Report: TAB Report
Function: Test, Adjust, & Balance
Date: 09/23/2025
Completed By: National TAB

PROJECT
09-22-25 WAWA #6625 LYNCHBURG, VA

Project: 09-22-25 WAWA #6625 LYNCHBURG, VA

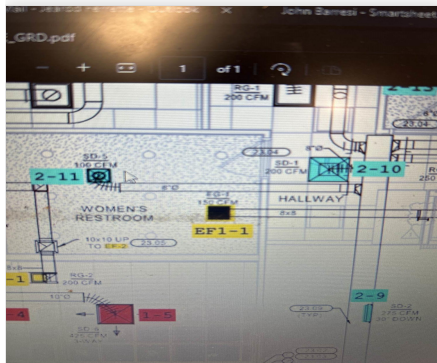
Issue Name : Missing women's restroom damper
Description : Woman's supply damper/ face damper missing. Currently at 275% off design.
Created By : National TAB **Assigned To :** National TAB - Brianna Biggs
Status : Open
Priority : Low **Asset Tag :** SGRD11
Originated Date : 09/23/2025 - Jearod Ferrette - National TAB

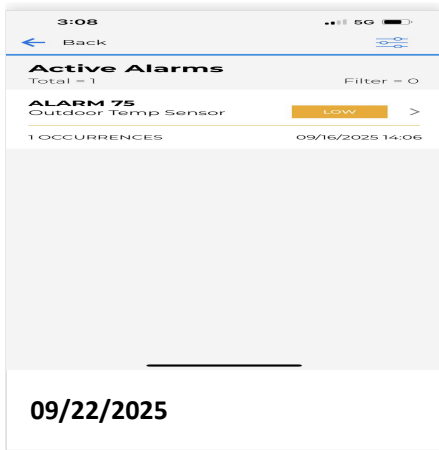
Issue Name : RTU 2 in alarm
Description : RTU 2 in alarm
Created By : National TAB **Assigned To :** National TAB - Brianna Biggs
Status : Open
Priority : Medium **Asset Tag :** RTU2
Originated Date : 09/22/2025 - Jearod Ferrette - National TAB

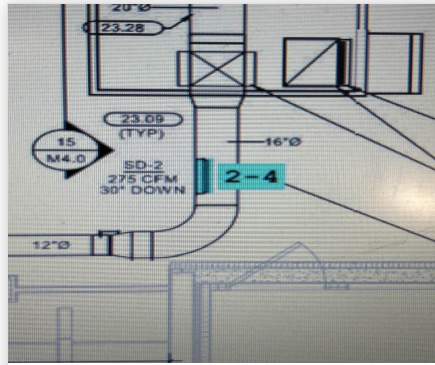
Issue Name : RTU 2 short 1 diffuser
Description : RTU 2 SGRD2-4 not installed on ductwork. Unit short 1 supply diffuser.
Created By : National TAB **Assigned To :** National TAB - Brianna Biggs
Status : Open
Priority : Medium **Asset Tag :** SGRD4
Originated Date : 09/22/2025 - Jearod Ferrette - National TAB

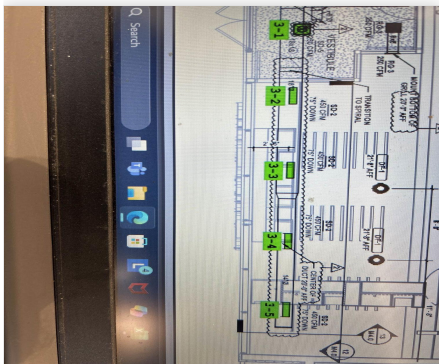
Issue Name : RTU 3 dampers inaccessible
Description : RTU 3 diffusers 3-1 & 3-5 are inaccessible with lift/ladder. Unit currently at total flow.
Created By : National TAB **Assigned To :** National TAB - Brianna Biggs
Status : Open
Priority : InfoOnly **Asset Tag :**
Originated Date : 09/22/2025 - Jearod Ferrette - National TAB

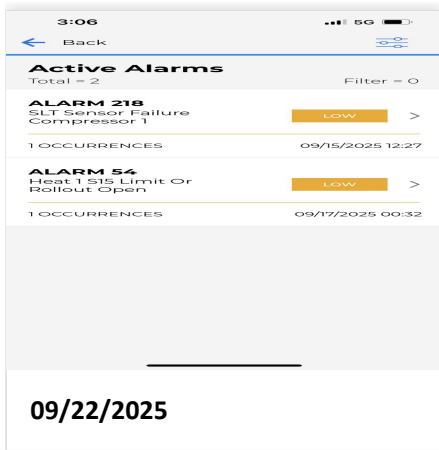
Issue Name : RTU 3 in alarm
Description : RTU 3 in alarm
Created By : National TAB **Assigned To :** National TAB - Brianna Biggs
Status : Open
Priority : Medium **Asset Tag :** RTU3
Originated Date : 09/22/2025 - Jearod Ferrette - National TAB
